GGNS PCOL-92/02 - MARKED-UP TECHNICAL SPECIFICATION PAGES

PCOL-92/02- PROPOSED TECHNICAL SPECIFICATIONS CHANGES

Attachment 4 to
GNRO-92/00034
Page 3 of 7

TABLE 3.3.6-1

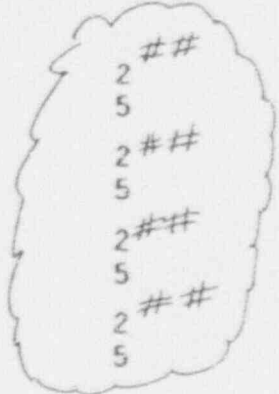
4.3.6.2 The provisions of specification 4.0.4 are not applicable to the Channel Functional test surveillances for the Intermediate Range monitors and Source Range monitors for entry into their applicable OPERATIONAL CONDITIONS (as specified in Table 4.3.6-1) from OPERATIONAL CONDITION 1, provided the surveillances are performed within 12 hours after such entry.

b. Inoperative	6	1, 2, 5	61
c. Downscale	6	1	61
d. Neutron Flux - Upscale, Startup	6	2, 5	61
3. <u>SOURCE RANGE MONITORS</u>			
a. Detector not full in ^(a)	4 2**	2 ## 5	61 62

b. Upscale ^(b)	4 2**	2 ## 5	61 62
c. Inoperative ^(b)	4 2**	2 ## 5	61 62
d. Downscale ^(c)	4 2**	2 ## 5	61 62
4. <u>INTERMEDIATE RANGE MONITORS</u>			
a. Detector not full in	6	2, 5	61

4.3.6.2 The provisions of Specification 4.0.4 are not applicable to the Channel Functional Test for the Intermediate Range Monitors and Source Range Monitors for entry into their applicable OPERATIONAL CONDITIONS (as specified in Table 4.3.6-1) from OPERATIONAL CONDITION 1, provided the surveillances are performed within 12 hours after such entry.

d. Neutron Flux - Upscale, Startup	6	2, 5	61
3. <u>SOURCE RANGE MONITORS</u>			
a. Detector not full in ^(a)	4	2##	61
	2**	5	62
b. Upscale ^(b)	4	2##	61
	2**	5	62

c. Inoperative ^(b)	4	2#	61
	2**	5	61
d. Downscale ^(c)	4	2##	61
	2**	5	62
4. <u>INTERMEDIATE RANGE MONITORS</u>			
a. Detector not full in	6	2, 5	61
b. Upscale	6	2, 5	61
